CITY OF PATASKALA BOARD OF ZONING APPEALS

STAFF REPORT

Variance Application VA-21-004

Location: 25 Depot Street, Pataskala, OH 43062

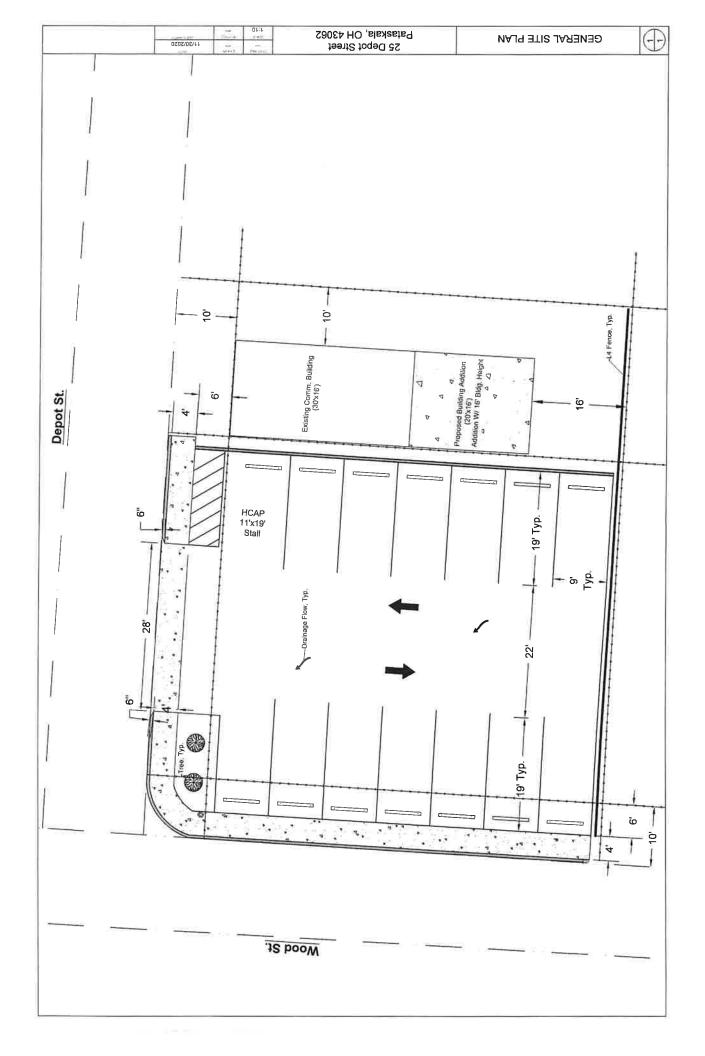
There is a hydrant and hydrant control valve on the corner of Wood and Depot Streets. The concrete sidewalk will not be permitted where the hydrant and valve are located. The hydrant and valve must remain in an area that is not asphalt or concrete. A possible suggestion might be to move the landscaping to be around the hydrant and for the sidewalk to curve along behind the hydrant, but the Utility director is open to discuss any feasible options.

- 2. In light of the Utility Director's commentary, the sidewalk at the corner of Wood and Depot Streets will need to be re-routed such that the fire hydrant at this location is not in concrete. This condition must be met, but the proposed improvement would be a benefit to the area, and there is willingness to find a mutually agreeable solution. Coordination with the Public Service Director and Utility Director is recommended.

3. Final Plans shall be provided that show the right-of-way, address the sidewalk, and also show proposed stormwater drainage including routing, inlets and tie-ins to the City infrastructure.

- 1. The Applicant should ensure the existing drainage pattern is not altered.
- 2. The City should consider drainage improvements and/or detention be required for the improvements per Chapter 1119.
